DEVELOPMENT APPLICATION ASSESSMENT REPORT

Application Number:	DA2021/1766
----------------------------	-------------

Responsible Officer:	Adam Mitchell
Land to be developed (Address):	Lot 8 DP 6984, 18 Alexander Street COLLAROY NSW 2097 Lot 9 DP 6984, 18 Alexander Street COLLAROY NSW 2097
Proposed Development:	Demolition works and construction of a housing development comprising five (5) self-contained apartments including basement car parking pursuant to SEPP (Housing for Seniors or People with a Disability) 2004
Zoning:	Warringah LEP2011 - Land zoned R2 Low Density Residential
Development Permissible:	Yes, under State Environmental Planning Policy (Housing for Seniors or People with a Disability) 2004
Existing Use Rights:	No
Consent Authority:	Northern Beaches Council
Delegation Level:	NBLPP
Land and Environment Court Action:	No
Owner:	Laxland Group Pty Ltd
Applicant:	Laxland Group Pty Ltd

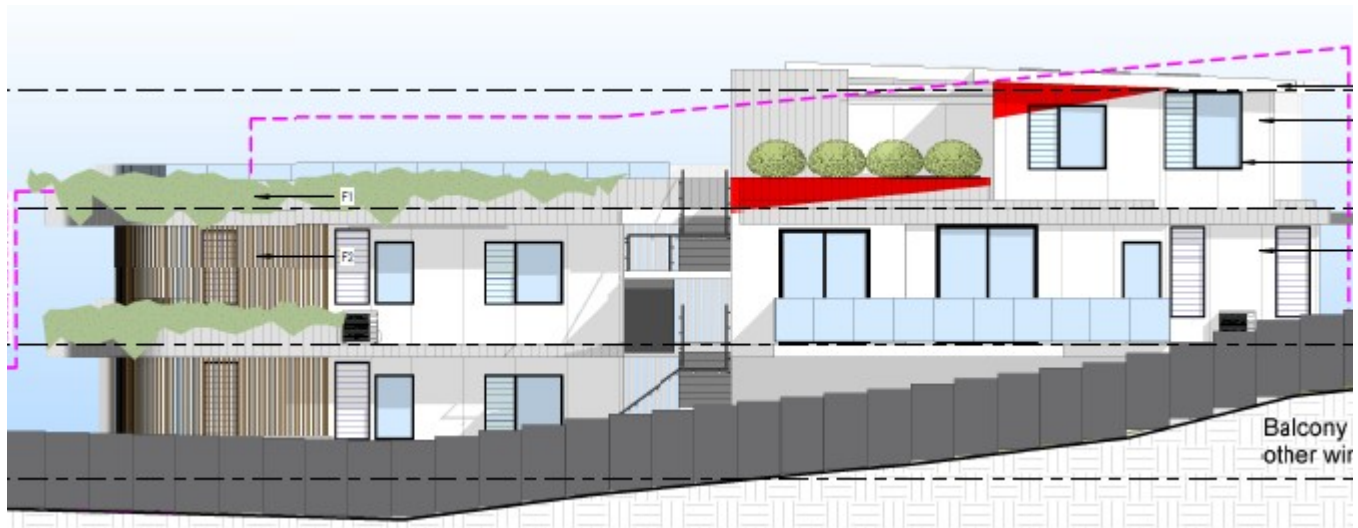
Comment:

The proposal provides a sufficient innovative roof pitch and is broken into two pavilions to ensure a visual break is afforded when viewed from the public or private domain.
